OSE Reference: 24070

Re: MCU for a tourist park on Fichera Road Mareeba for R & M Patane – MSC request for information – MCU/23/0021.

We refer to Mareeba Shire Council's RFI dated 3rd November 2023, which requested a traffic impact assessment to determine whether the additional traffic generated by this proposal, would have any significant impact on road safety for the users of Fichera Road.

DATE: FEB 2023
 SCALE: AS SHOWN ON 'A3' SHEET
 DRAWING TITLE:
PROPOSED OVERALL SITE
 JOB NO. SHEET No. ISSUE
 0744 **DA 01** **C**

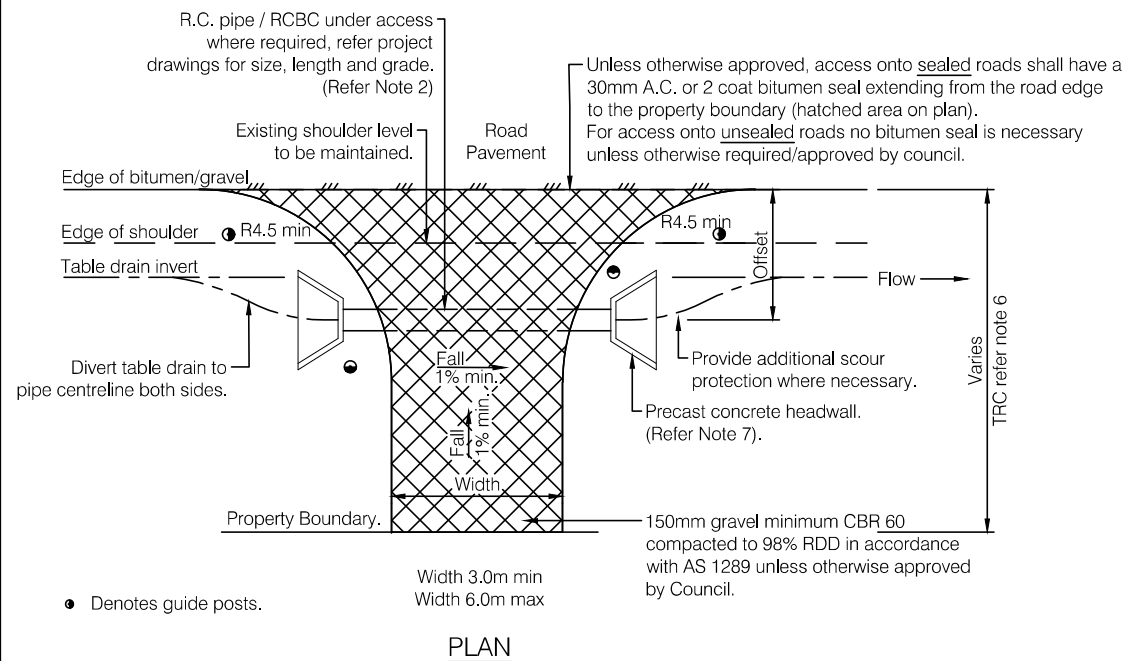
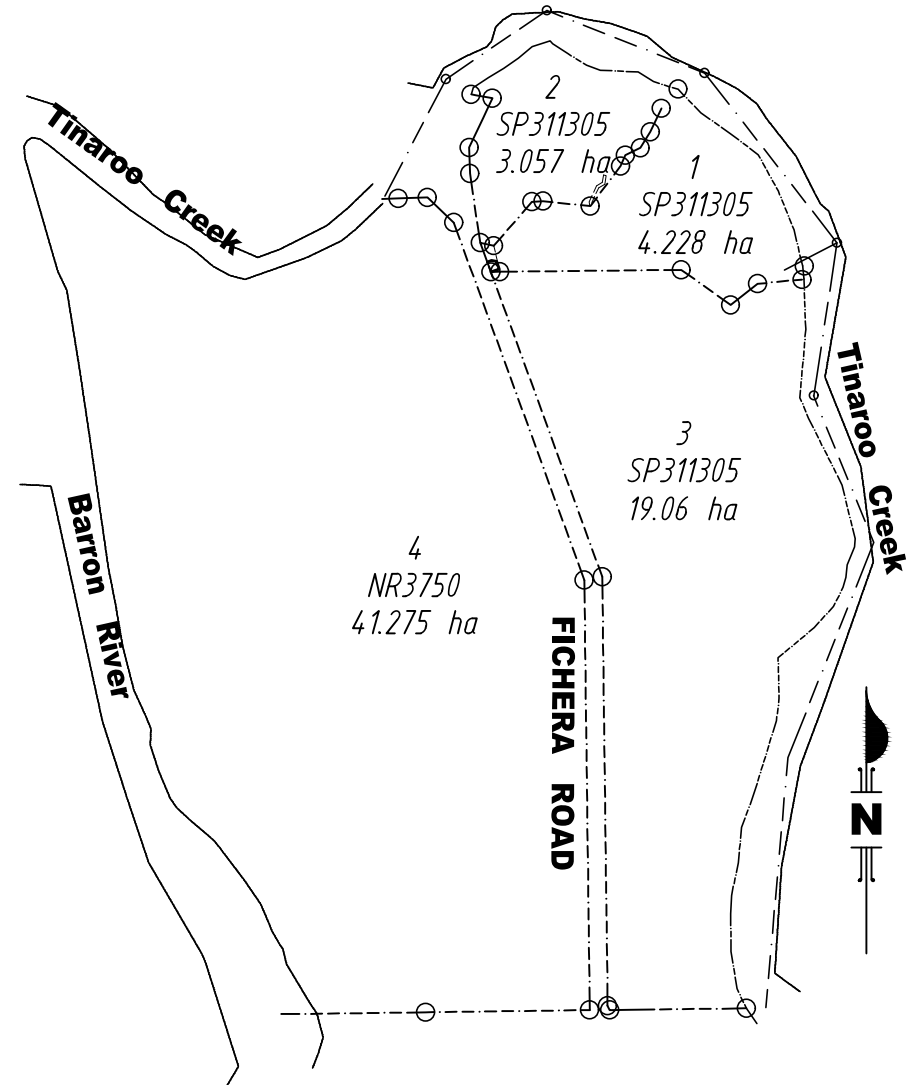
The project includes the provision of 16 camping sites located in 5 separate areas, four of these will be served by 1 access to Fichera Road and the remaining site served by a separate access located approximately 275 metres apart. The overall site and access locations are shown on the attached site plan.

- a) There is no significant impact on the existing bridge over Tinaroo Creek.
- b) There is no significant impact on the Fichera Road/Tinaroo Creek Road intersection.
- c) Given the existing width and condition of Fichera Road, there is no significant impact on this road.

Standard Drawing
S1105

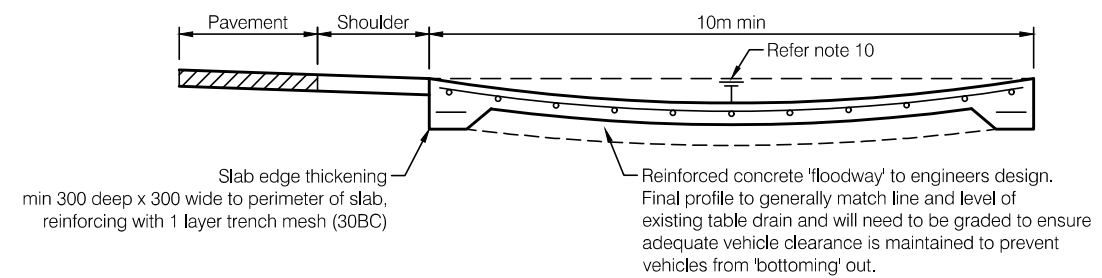
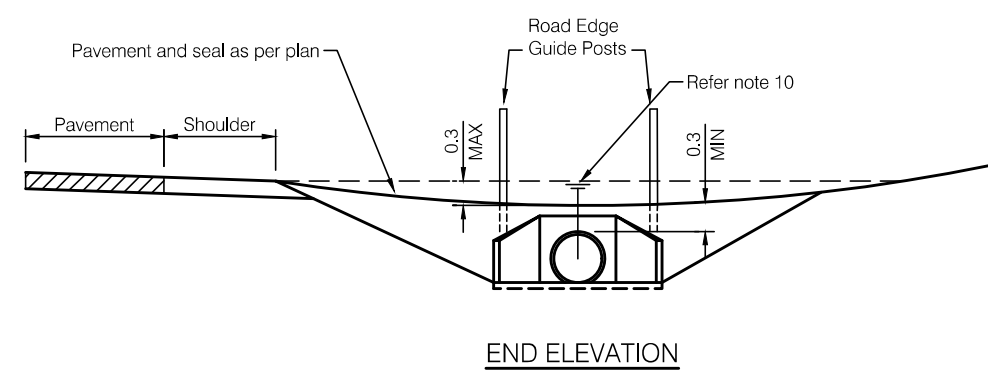
On this basis there are no safety issues on Fichera Road, and no upgrading works are required. However, for safety reasons and controlled turning of vehicles from Fichera Road into the two access points we recommend that these accesses should be upgraded to provide a sealed entry from the edge of the bitumen seal to the property boundary. Provision should be made for culverts or causeways to accommodate stormwater flows along Fichera Road if required. These accesses should be constructed in accordance with FNQROC drawing S1105 with a minimum entry width of 4 metres. A copy of the relevant drawing is attached.
